Re: Minor Project Refinement No. 18 for the South Orange County Reliability Enhancement Project.

South Orange County Reliability Enhancement Project CPUC Minor Project Refinement Form

Report No.: 18

ATTACHMENT B
MPR-18 Figure

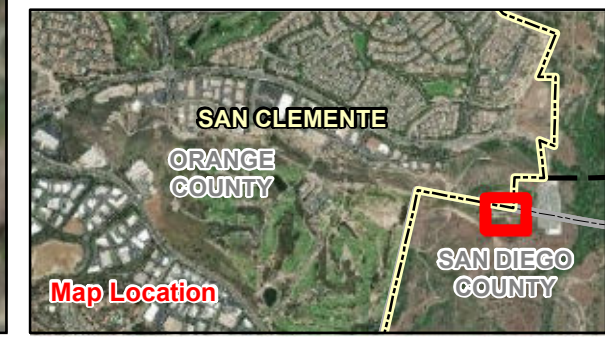
San Diego Gas and Electric (SDG&E) is requesting approval of MPR-18 for an additional work area for the South Orange County Reliability Enhancement Project (SOCRE or Project). The new work area is contiguous with the location 18A work area (previously approved in Notice to Proceed No. 7 (NTP-7)) as shown in **Attachment B, MPR-18 Figure**. The proposed MPR-18 work area will total approximately 410 square feet (0.009 acre), of which 55 sq. ft (0.001 acre) are permanent impacts for a brow ditch extension, and 355 sq. ft. (0.008 acre) are temporary impacts for the additional workspace required to construct the brow ditch.

The MPR-18 work area addition will be utilized to extend the original brow ditch design at location 18A as a form of erosion control. Excavation will take place within the 55 sq. ft. permanent impact

area to construct the brow ditch at location 18A. This 15-foot area will be excavated using hand tools or a mini excavator to a width of two feet and a depth of two feet, and then backfilled with base to form a V-ditch. The 355 sq. ft. temporary impact area will be used as additional workspace required to perform the brow ditch expansion. Trimming (mowing) will be required for disturbed vegetation within the MPR-18 work area. **Attachment B, MPR-18 Figure** shows the location of the MPR-18 work area.

The proposed work area is contiguous to a previously approved Project component, location 18A, which was approved in NTP-7 and the Amended REIR document. Two temporary work areas included in NTP-7 and the REIR (located south of the location 18A work area) will no longer be used by the Project (see **Attachment B, MPR-18 Figure**). As such, the overall temporary impact was reduced in this area as final engineering eliminated the need for those temporary poles and associated work areas (see Disturbance Acreage Changes Section below for detail).

The proposed MPR-18 work area totals 410 sq. ft. (0.009 acre), of which 55 sq. ft. (0.001 acre) is permanent disturbance for the brow ditch extension and 355 sq. ft. (0.008 acre) is temporary disturbance.

It should be noted, two temporary work areas included in NTP-7 and the REIR located south of the location 18A work area will no longer be used by the Project. These work areas total 5,800 sq. ft. (0.133 acre). As such, the total temporary disturbance in the area of 18A would still result in an overall reduction of 5,445 sq. ft. (0.125 acre) with the addition of the MPR-18 area.

- COA-1. The extent of the MPR-18 disturbance areas will be limited to the areas shown on the figure titled "SOCRE PROJECT MPR-18 Figure" and will be used for project construction staging and related activities only during the period of project construction and restoration (anticipated to be approximately through the first quarter of 2025).
